Subject: Submittal of the Response to the Notice of Disapproval Baseline Geomorphic Conditions at Sediment Transport Mitigation Sites in Los Alamos/Pueblo Canyon Watersheds and Revision 1

**Response to the Notice of Disapproval for the Report on Baseline Geomorphic Conditions at
Sediment Transport Mitigation Sites in the Los Alamos and Pueblo Canyon Watersheds
Los Alamos National Laboratory EPA ID No: NM0890010515, HWB-LANL-08-004,
Dated January 31, 2011**

Baseline Geomorphic Conditions at Sediment Transport Mitigation Sites in the Los Alamos and Pueblo Canyon Watersheds, Revision 1

Figure 22 Cross sections near the DP Canyon GCS

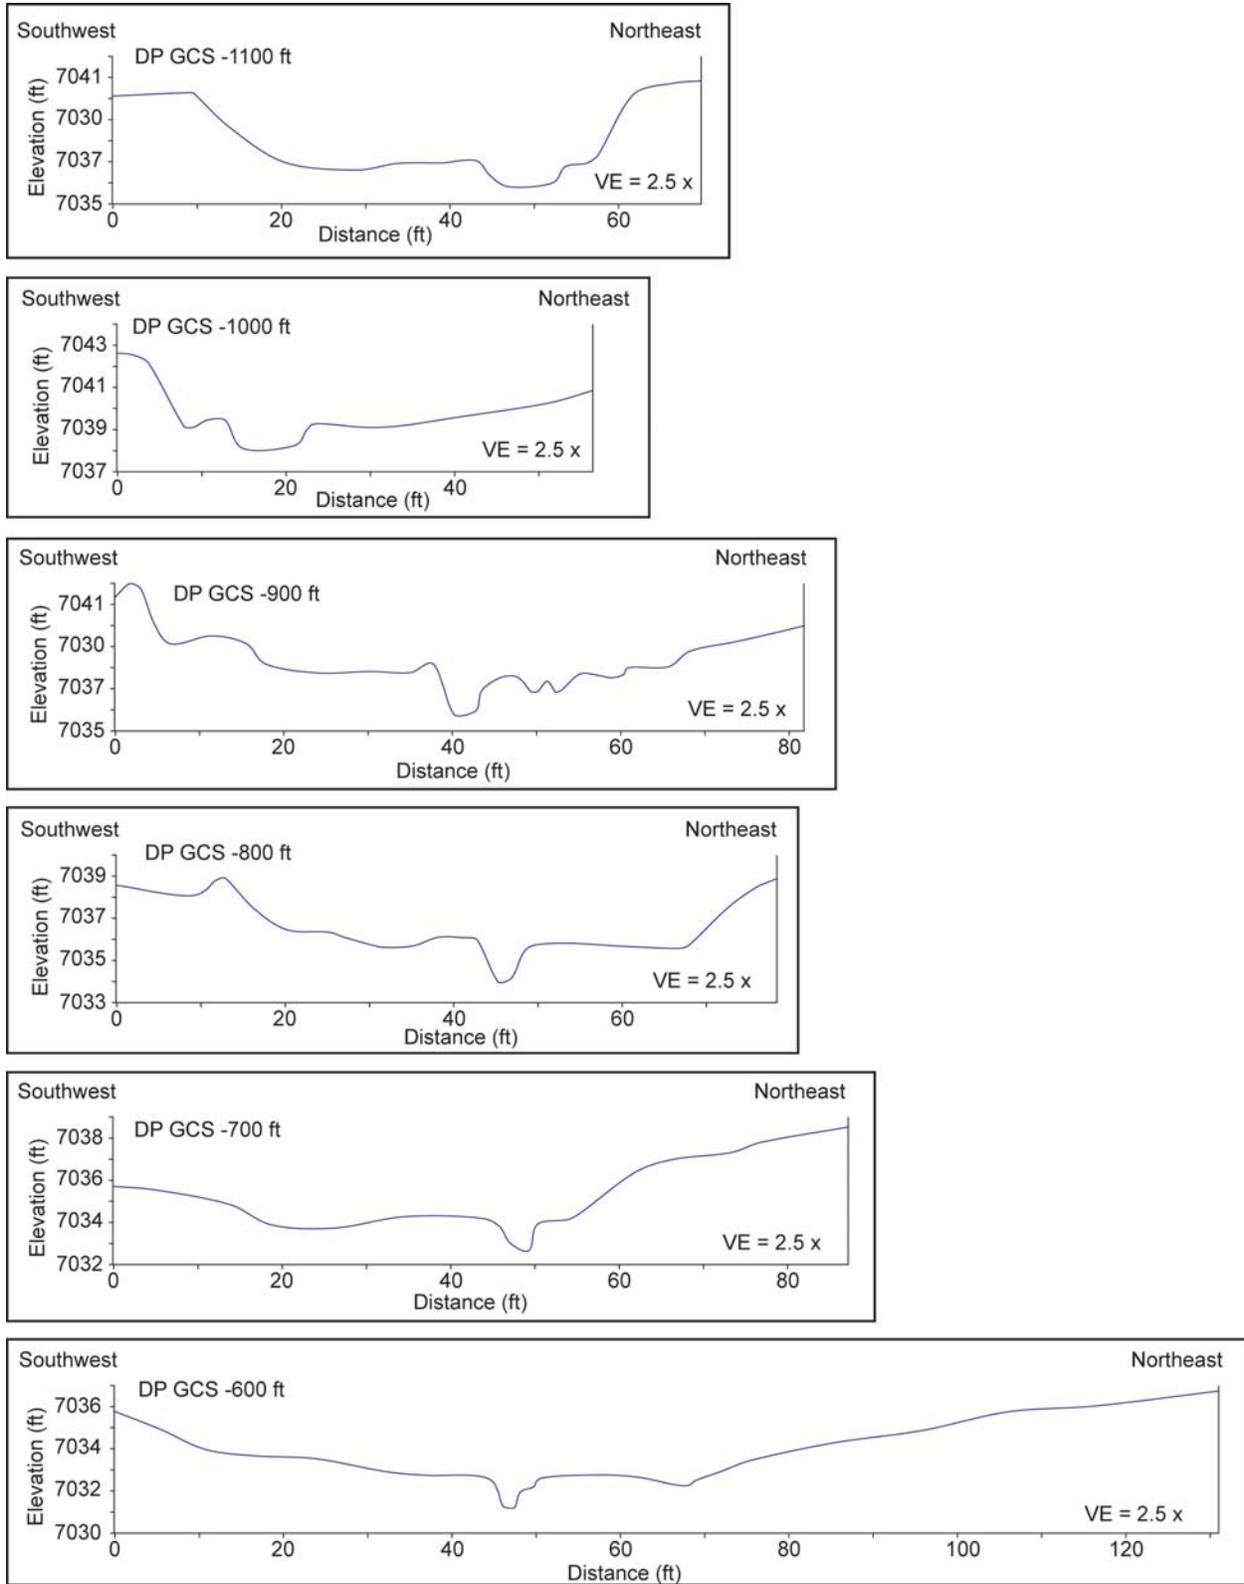
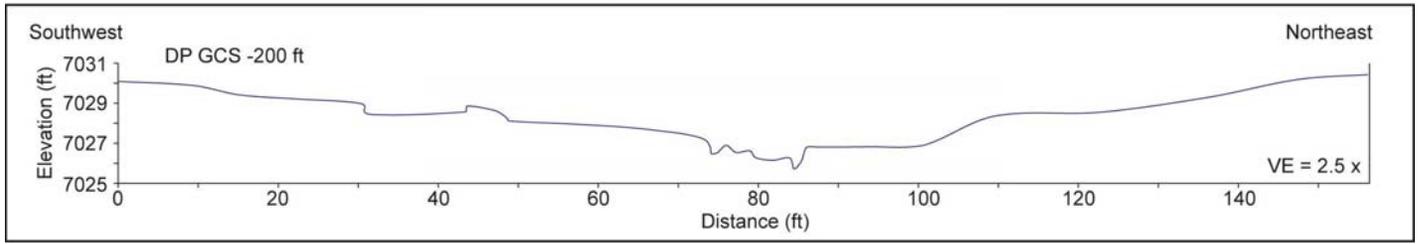
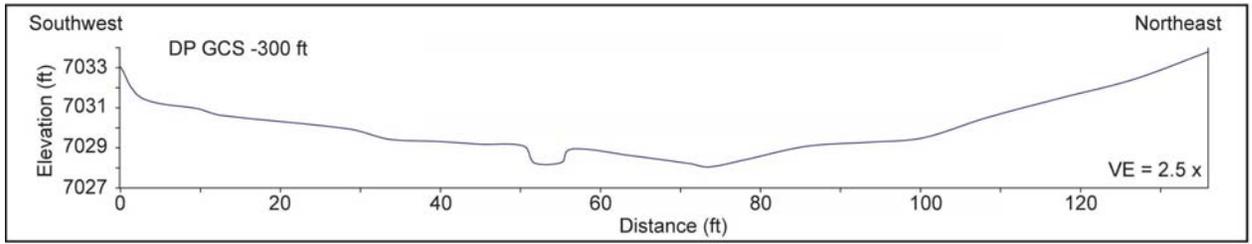
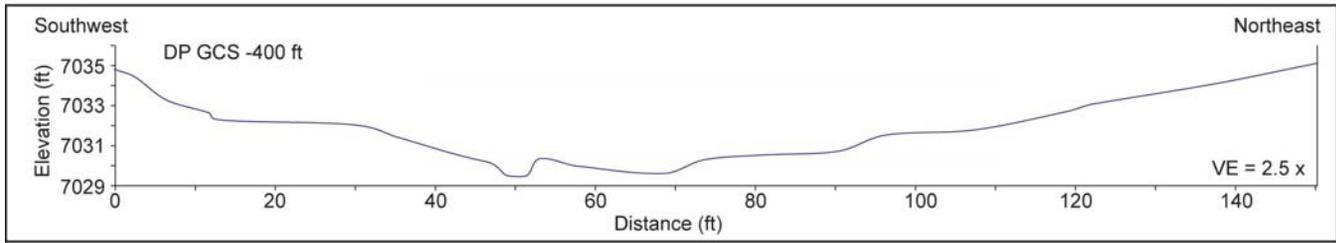
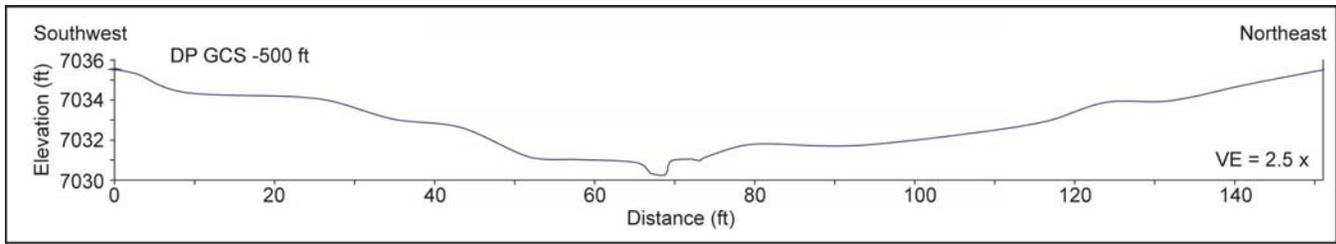
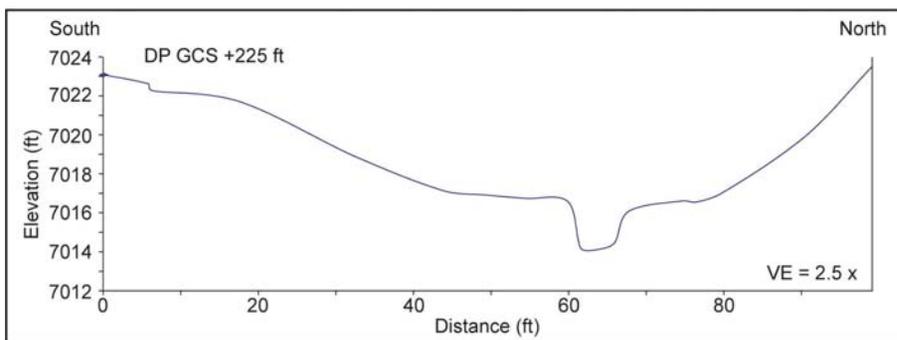
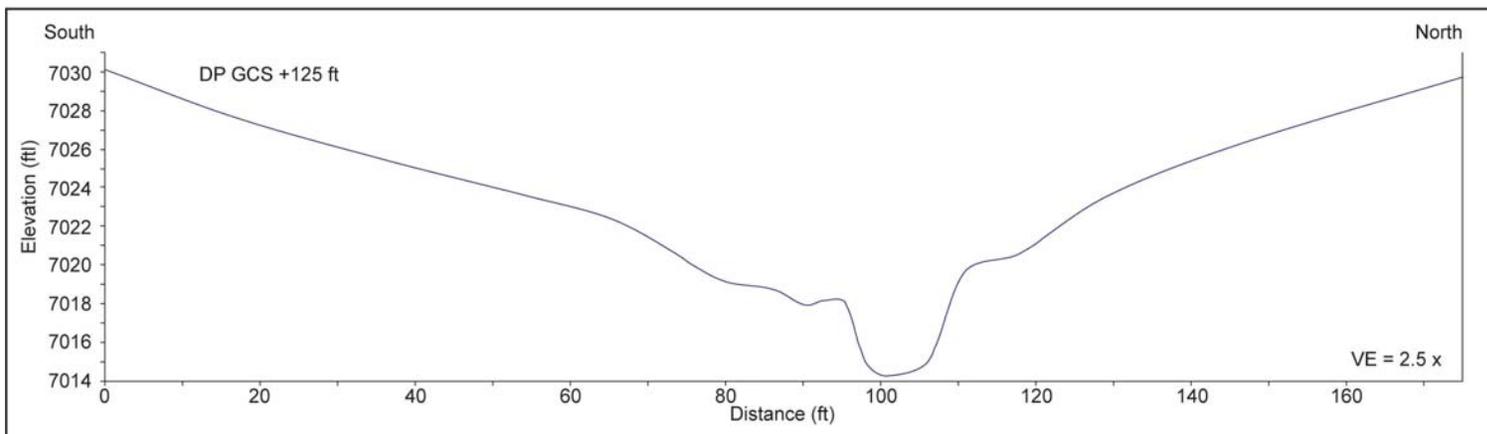
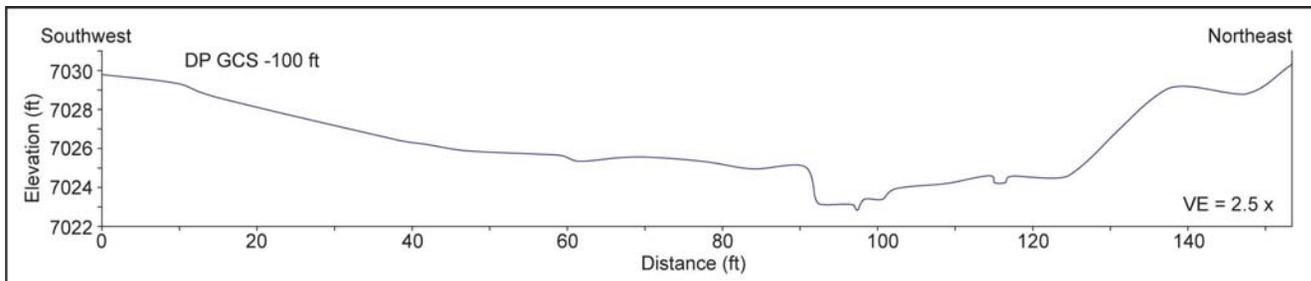
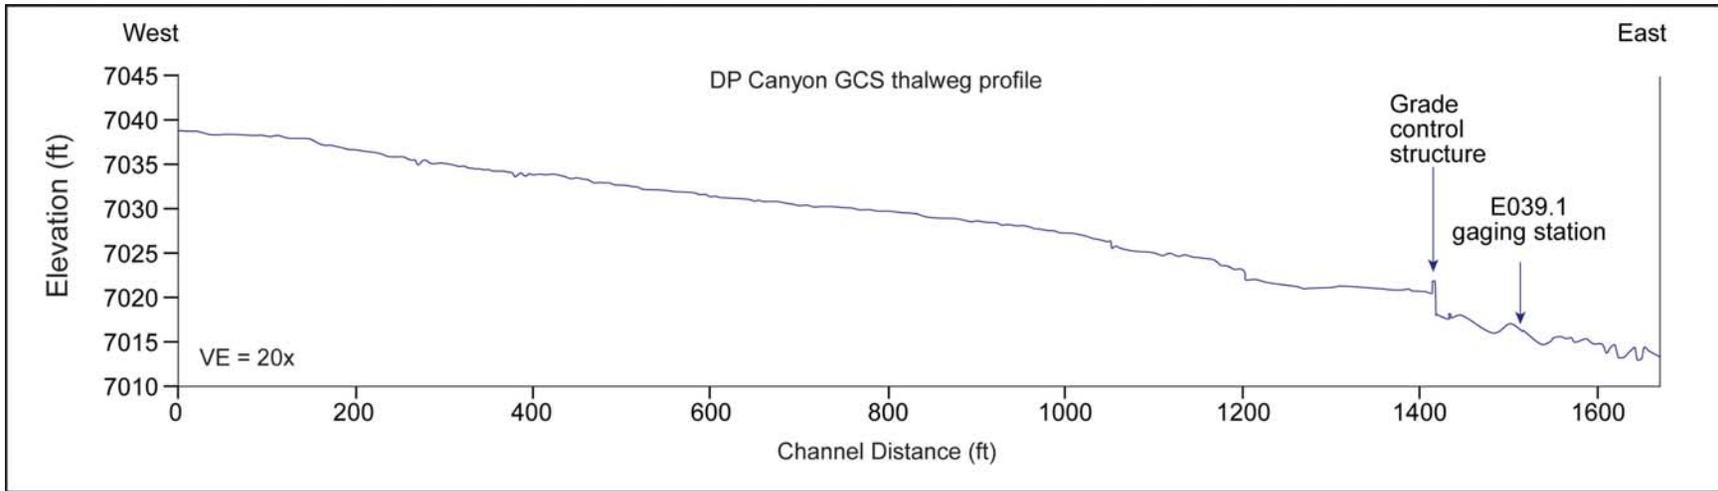
2. *Figures 3, 4, 5, 7, 8, 9, 10, 12, 13, 15, 16, 18, 19, 22, and 23 consist of multiple 2-dimensional graphs, with elevation on the Y axis and distance on the X axis, depicting cross sections and thalweg profiles. The survey data used to generate the graphs were provided by the Permittees in Attachment 1. According to the Permittees, a "Geodimeter 620 total station survey method" was employed to generate the graphs. NMED could not interpret the coordinates provided in Attachment 1 or reproduce the graphs as depicted in Figures 3, 4, 5, 7, 8, 9, 10, 12, 13, 15, 16, 18, 19, 22, and 23. Provide the data in a format that can be used by NMED to reproduce the graphs and evaluate the cross sectional features.*

2. The survey data were obtained using either a total station or a global positioning system and used the New Mexico State Plane coordinate system. Graphs were prepared using Excel software after first converting the x and y coordinates to distance from the end of each section or profile. This conversion involved basic trigonometry (Pythagorean theorem). Columns have been added to the tables in Attachment 1 showing the calculated distances along each section or thalweg profile for each survey point (excluding benchmarks). The text has also been revised to describe this conversion.

Figure 18 Cross sections near the Pueblo Canyon GCS

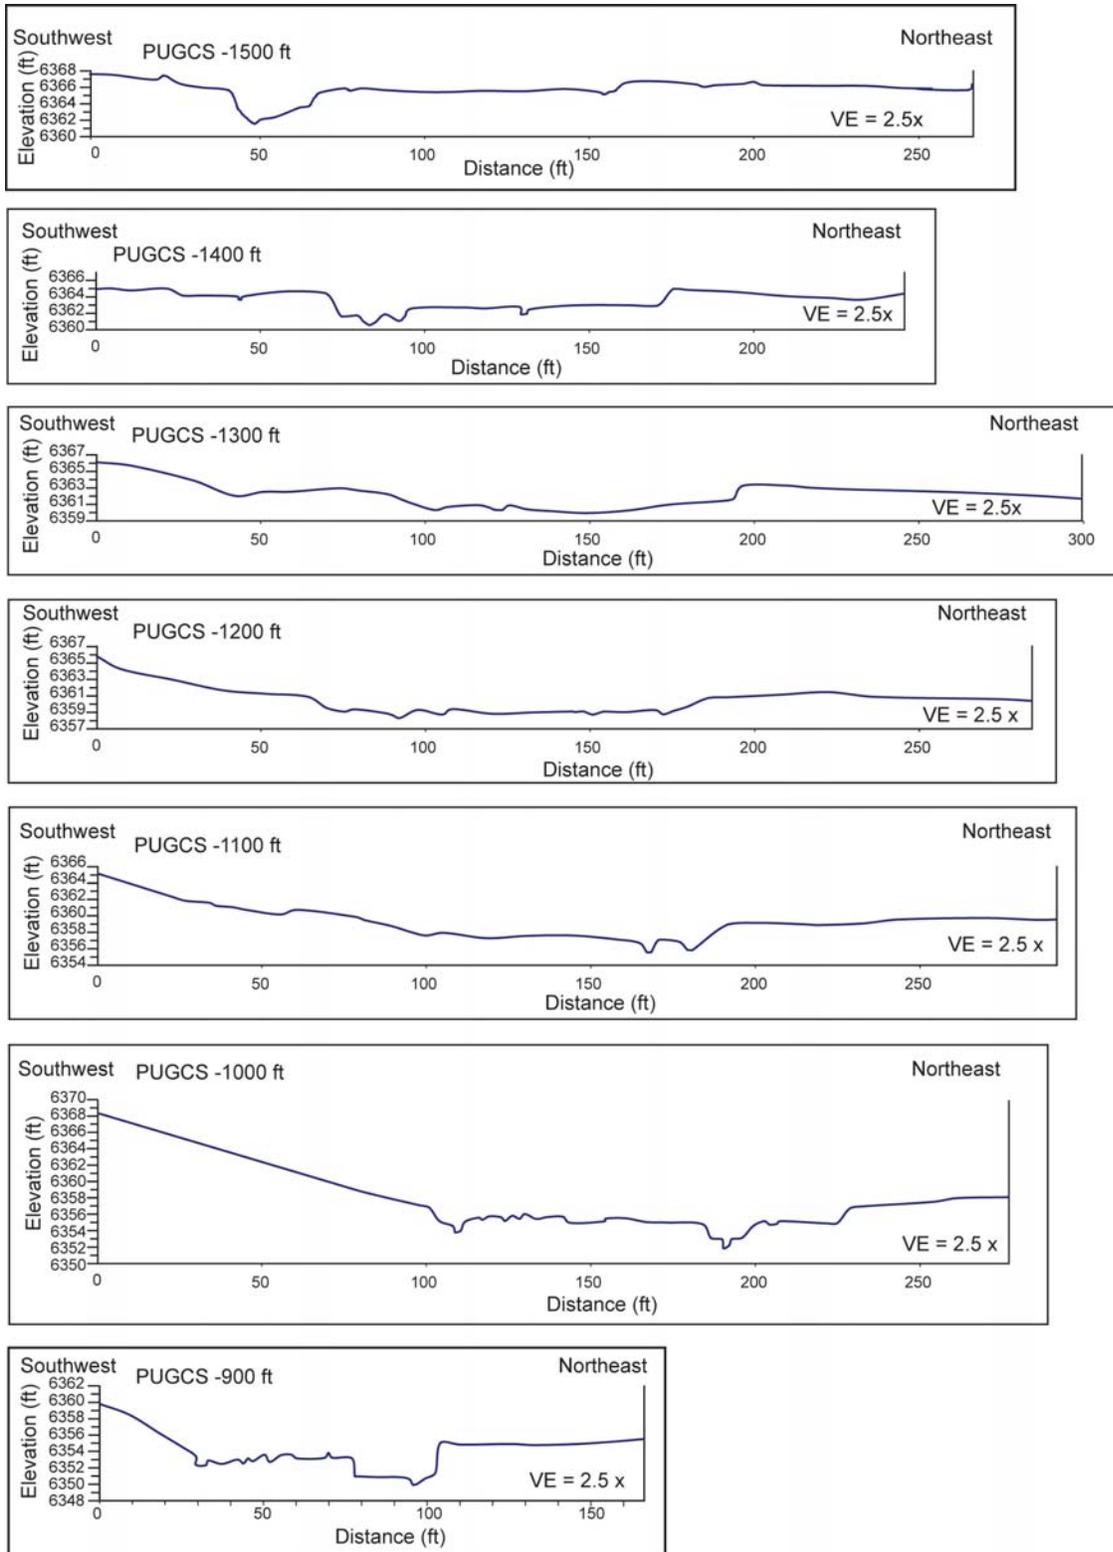
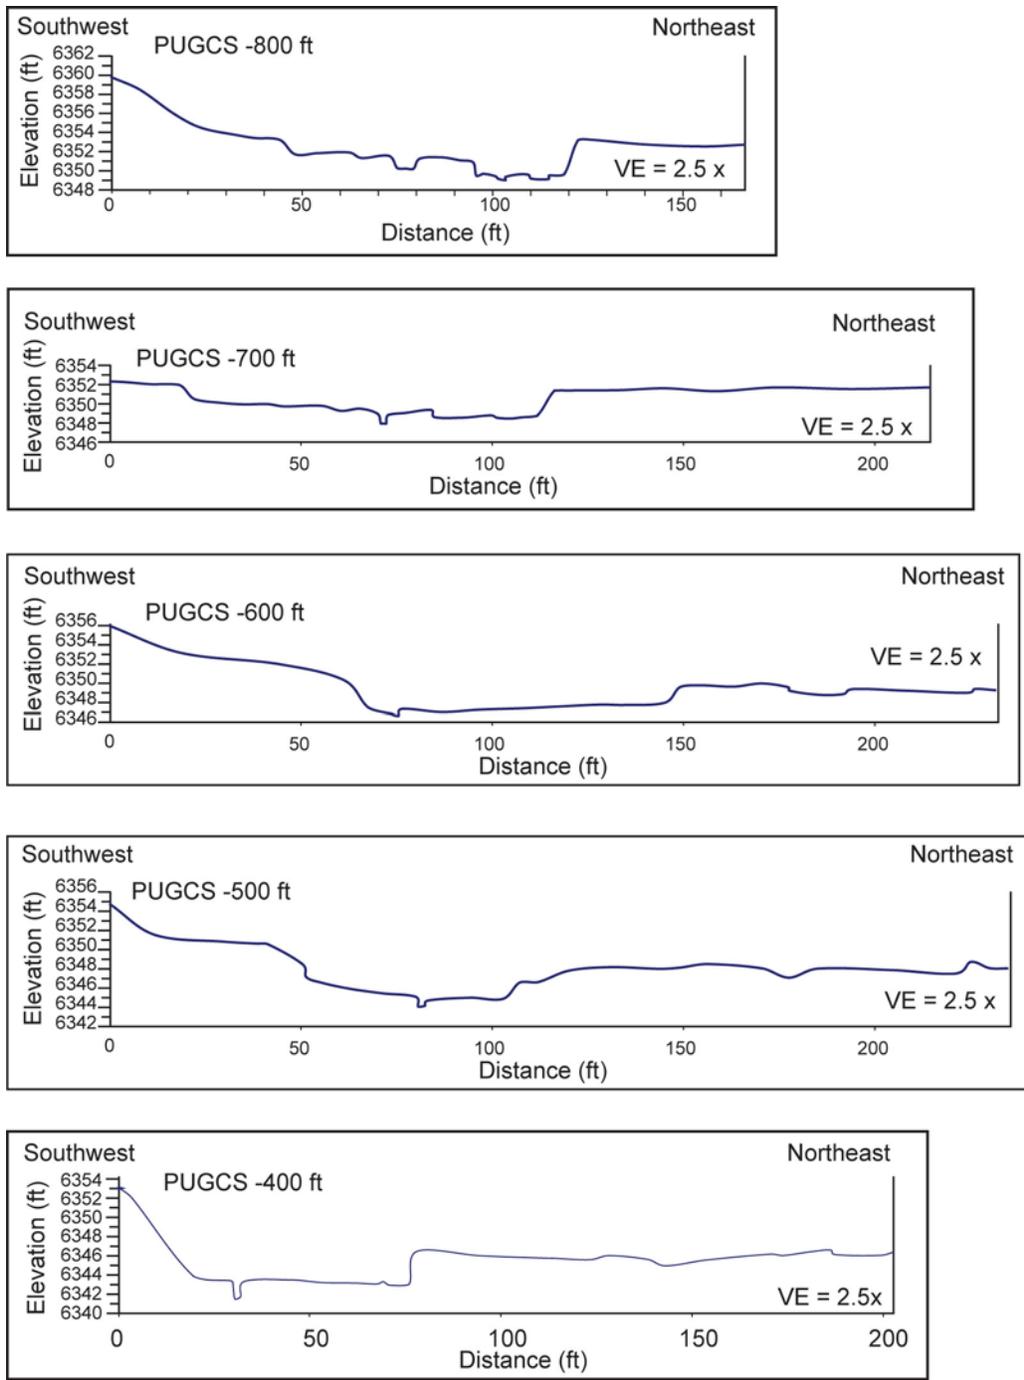
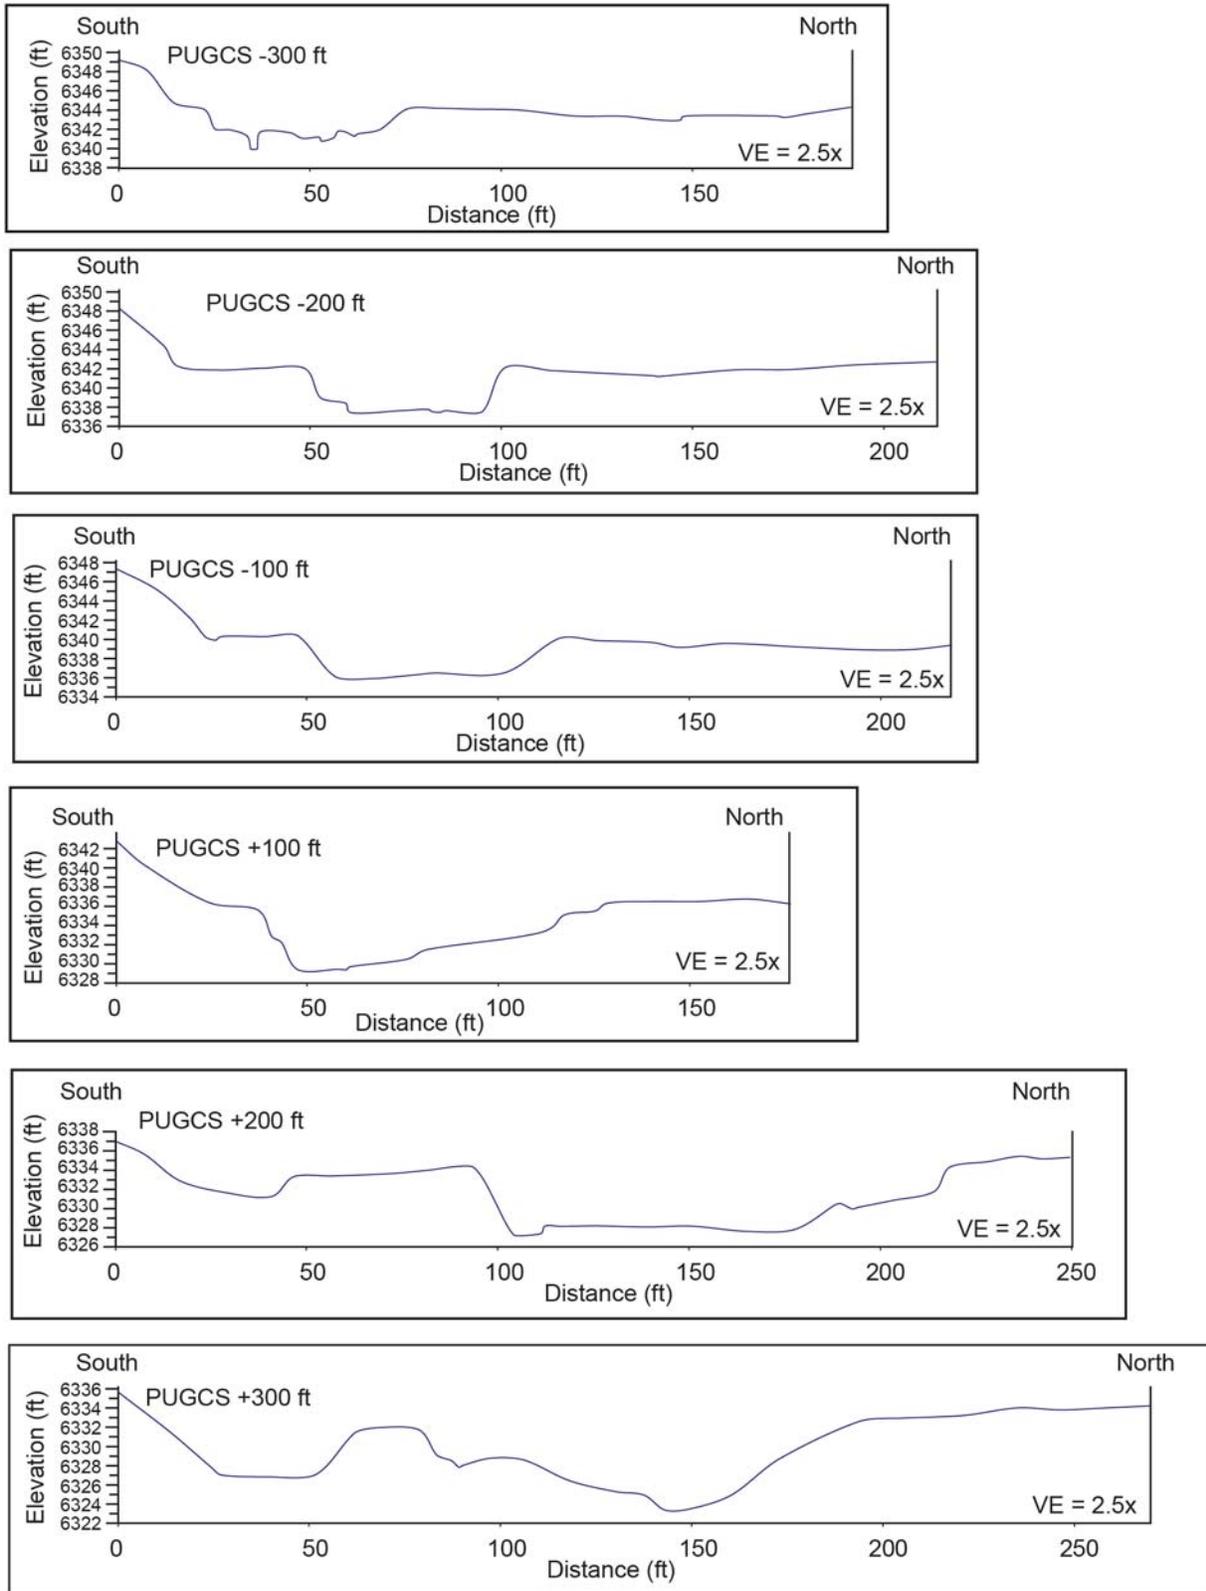
1. *Figure 18 (pages 29 - 30), composed of multiple graphs, depicts cross section surveys of Pueblo Canyon near the Pueblo Canyon Grade Control Structure (GCS). According to the Monitoring Plan for Los Alamos and Pueblo Canyons Sediment Transport Mitigation Project, dated October 2009, the Permittees planned to survey a minimum of fifteen cross sections at 100-ft intervals for a distance of 1500 ft up canyon of the planned Pueblo Canyon Grade Control Structure and three cross sections at 100-ft intervals down canyon of the structure. Six cross sections are missing from Figure 18; the three cross sections up canyon and the three cross sections down canyon adjacent to the grade control structure. The missing cross section surveys are identified as -300, -200, -100, + 100, +200 and +300 in Figure 17, page 28. Revise the Baseline Report to include the missing cross sections in Figure 18 or explain why the cross sections were not surveyed.*

1. These cross sections were surveyed in April 2010 and the survey data were included in Attachment 1 of the report, but these cross sections were inadvertently left out of Figure 18 during compositing. The report has been revised to include these cross sections in Figure 18.
